Access Compliance Report

Public Rights-of-Way

(Curb Ramps)

Intersection ID: 23715	Main Street: BRANDON_FOREST_DR	Cross Street: VON_THURINGER_CT	Location: SE
ADA ID: B7930729CDD1	Ramp Type: PerpDiag	Initial Pass/Fail: Fail	Overall Compliance: No
Severity Score: 8.75			
Codes/Mitigation Info/Possible Solution		Field Measurements/Component Compliance

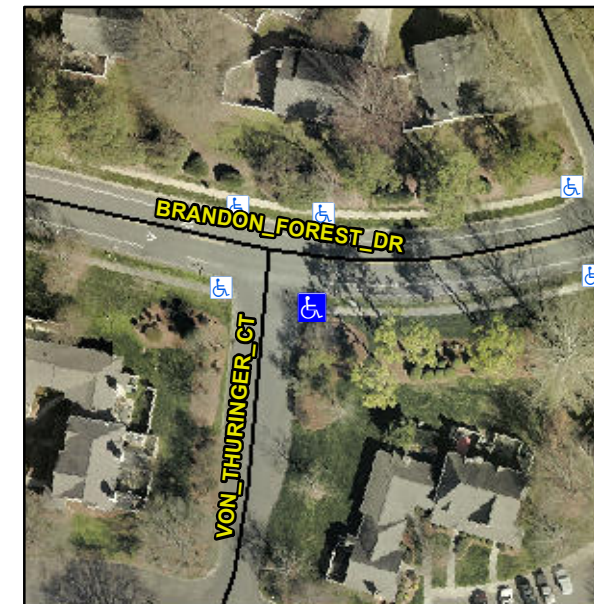
Not Found, R304.5.1

Compliance	Description	Data	Compliance	Description	Data
N/A	Ramp Length (in)	41.0	Yes	Ramp Slope (%)	5.3
No	Ramp Width (in)	46.0	Yes	Ramp XSlope (%)	1.6
N/A	Flare Type LT	N/A	N/A	Flare Type RT	N/A
N/A	Flare Slope LT (%)	N/A	N/A	Flare Slope RT (%)	N/A
N/A	Flare Traversable LT?	N/A	N/A	Flare Traversable RT?	N/A
N/A	Landing Length (in)	N/A	N/A	DWS Provided?	N/A
N/A	Landing Width (in)	N/A	N/A	DWS Contrast?	N/A
N/A	Landing Slope (%)	N/A	N/A	DWS Length (in)	N/A
N/A	Landing X Slope (%)	N/A	N/A	DWS Full Width?	N/A
N/A	Landing Curb? (Y/N)	N/A	N/A	DWS Offset (in)	N/A
N/A	Shared Landing?	N/A			
N/A	Gutter Ponding?	N/A	N/A	Gutter Slope (%)	N/A
N/A	Gutter Lip Ht (in)	N/A	N/A	Gutter X Slope (%)	N/A
N/A	Painted X Walk1?	No	N/A	Painted X Walk2?	No
	X Walk 1 Direction	To N		X Walk 2 Direction	To NW
N/A	X Walk 1 Width (in)	N/A	N/A	X Walk 2 Width (in)	N/A
	X Walk 1 Slope (%)	4.3		X Walk 2 Slope (%)	0.3
	X Walk 1 X Slope (%)	0.8		X Walk 2 X Slope (%)	0.3

Remove & Replace Curb Ramp With Two New Directional Ramps or Equivalent.
